SERVICE BULLETIN

PASSENGER / CREW 90° RELEASE
LAP BELT BUCKLE ASSEMBLY

SERVICE BULLETIN NUMBER
1108460-25-01

Subject: REPAIR OR REPLACEMENT OF PACIFIC SCIENTIFIC LAP BELTS
AND RESTRAINT SYSTEMS WHICH INCORPORATE THE 1108460
90° RELEASE LIFT LEVER BUCKLE ASSEMBLY

FIGURE 1

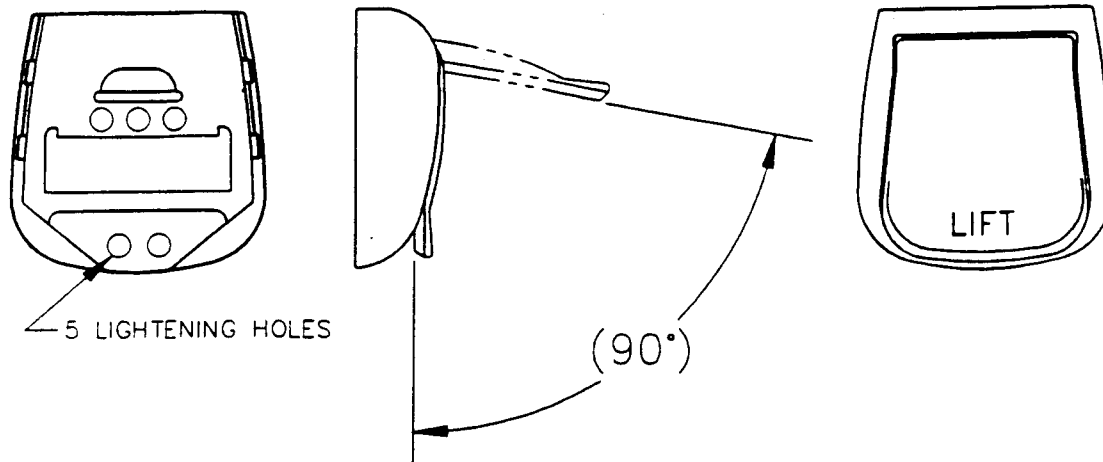
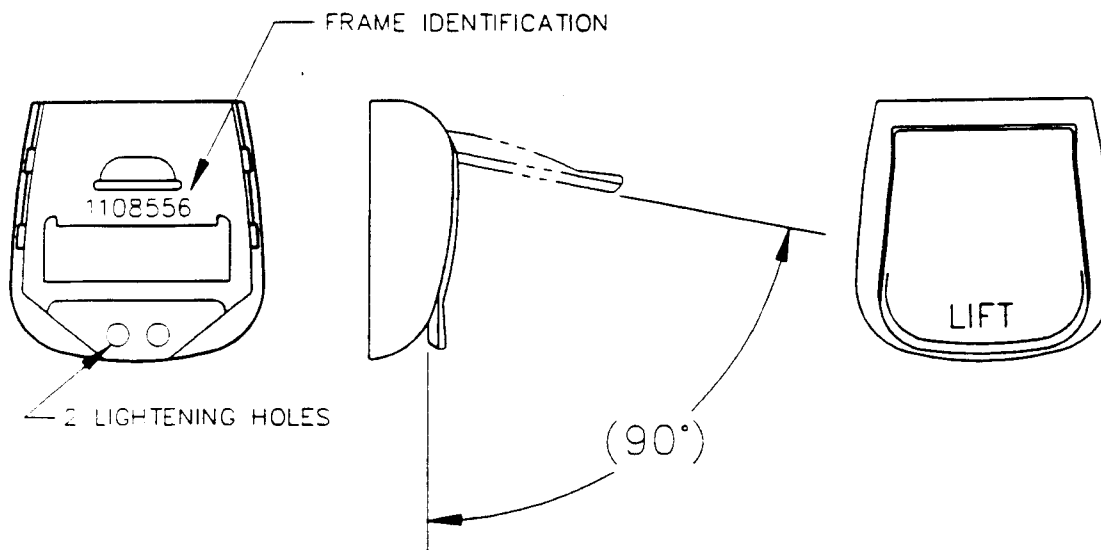
- 1) Inspect the crew restraint system or the lap belt assembly in which an 1108460 buckle is installed. The buckle can be easily identified by the lift lever characteristic, but more so by the composite plastic components which enclose the metal load carrying members of the buckle. The existing buckle design, which must be replaced, has a total of five lightening holes in the bottom frame surface. The retrofit buckle will only have two lightening holes (towards the back portion of the frame, opposite from where the plug-in connector inserts into the buckle). The retrofit buckle will also have an identification marking indent stamped on the bottom surface, which represents the frame detail part number 1108556. See Figure 1 and 2 for reference.

NOTE: *For purposes of inspection and future reference, the markings on the bottom surface of the buckle (1108556) and the reduction in the number of lightening holes (two towards the back of the frame) shall be the method of identification for compliance with this Service Bulletin. In addition to the buckle identification, the identification label of each lap belt assembly incorporating a lift lever buckle, shall have an "M" included in the basic part number.*

IDENTIFY EXISTING 1108460 BUCKLES BY COUNTING THE FIVE LIGHTENING HOLES IN BOTTOM SURFACE OF FRAME

UPGRADED 1108460M BUCKLE DESIGN HAS AN IDENTIFICATION MARKING AND TWO LIGHTENING HOLES IN THE BOTTOM SURFACE OF FRAME
